Service instruction: SM013E
Revision: 1
Date: 05-01-2011
Page no.: 1

Title: Guide roller securing retrofit

This work instruction describes how to determine whether a retrofit of the guide roller securing is necessary and how to execute the retrofit.

10.4. Checking the setting dimensions between the door rail and the lower arm of the door shaft.

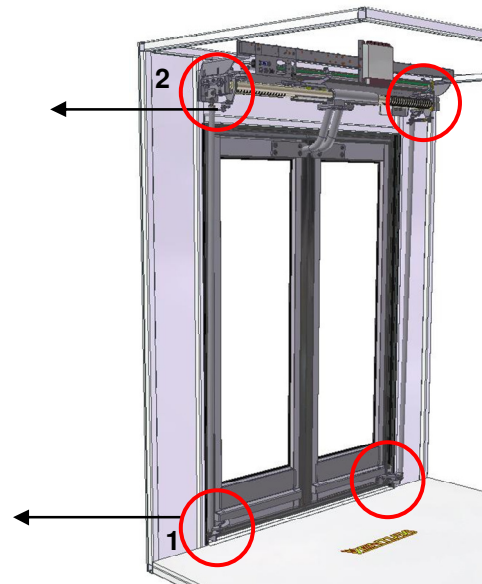
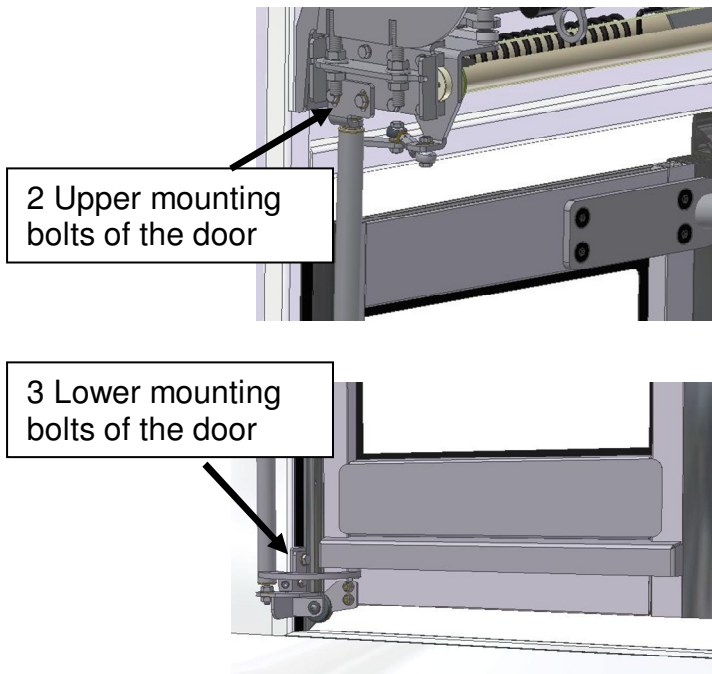
10.4.1. The door shafts can be adjusted independently.

10.4.2. In order to modify the dimension between the door rail and the lower arm of the door shaft, the door shaft must be shifted upwards or downwards.

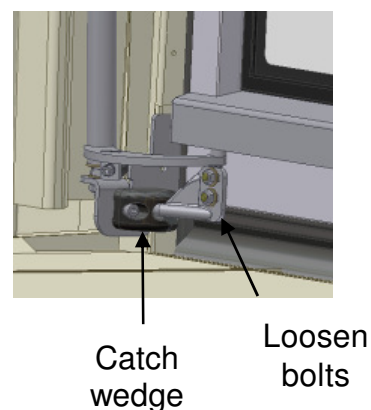
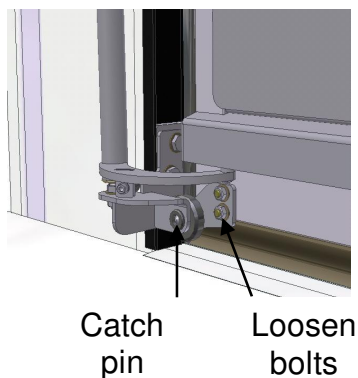
- 10.4.3.3. Successively loosen the upper and lower mounting bolts of the door shaft.
- 10.4.3.4. Adjust the dimension between the door rail and the lower arm of the door shaft to between 4 mm and 8 mm by shifting the door shaft upwards or downwards along the slots. Then tighten the mounting bolts of the door shaft. Tightening torque: 20 Nm.
- 10.4.3.5. In some rare cases, it may happen that the setting dimension (4 mm to 8 mm) is not achieved by adjusting the door shaft. In these cases contact Ventura Systems.

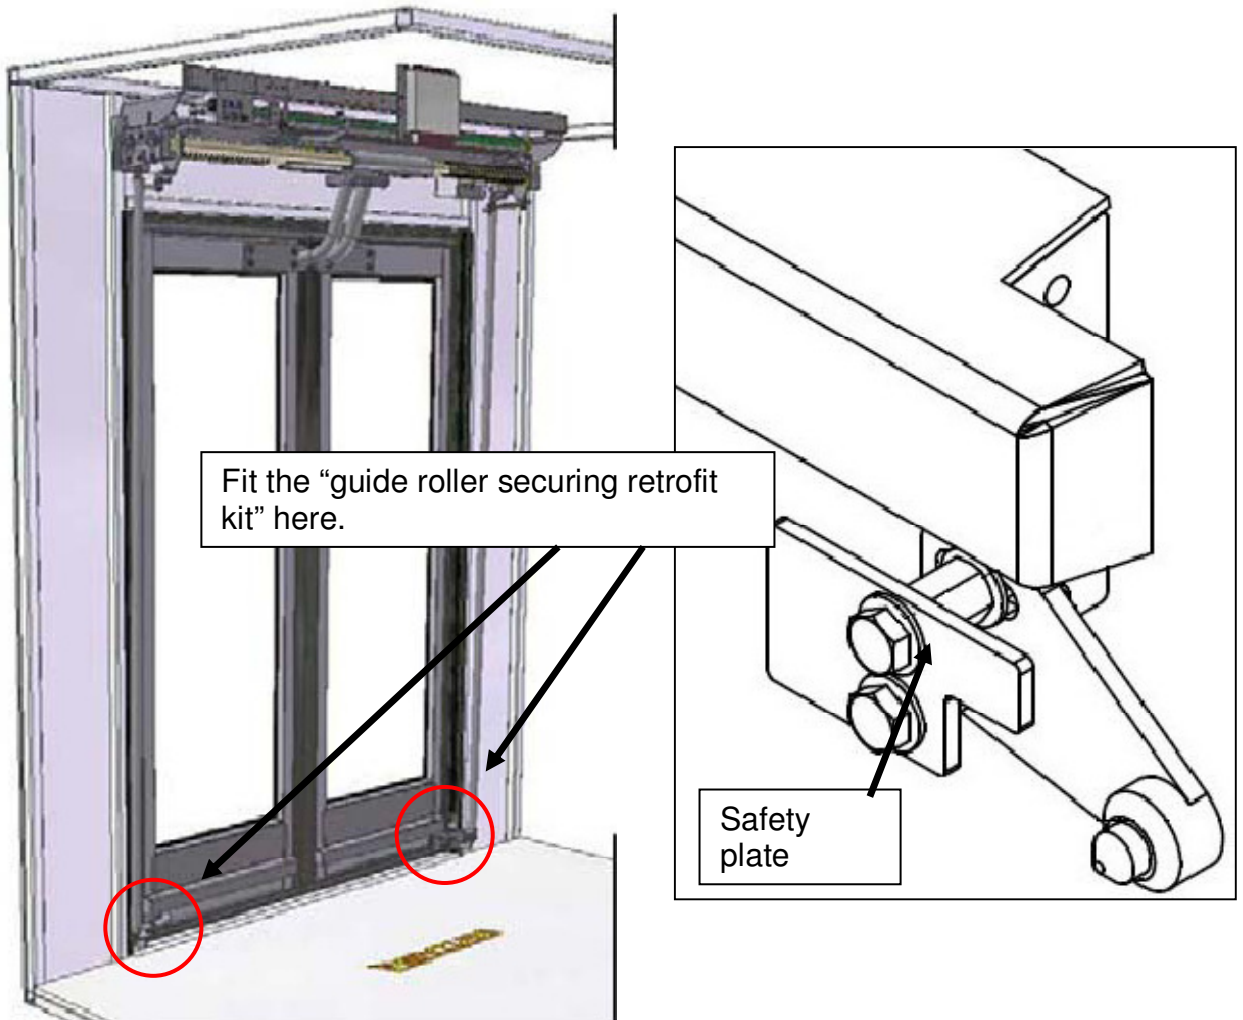
- 10.4.3.6. Check if the catch pins or catch wedges are positioned correctly. If necessary adjust the catch pins or catch wedges. There are two different versions as shown below.
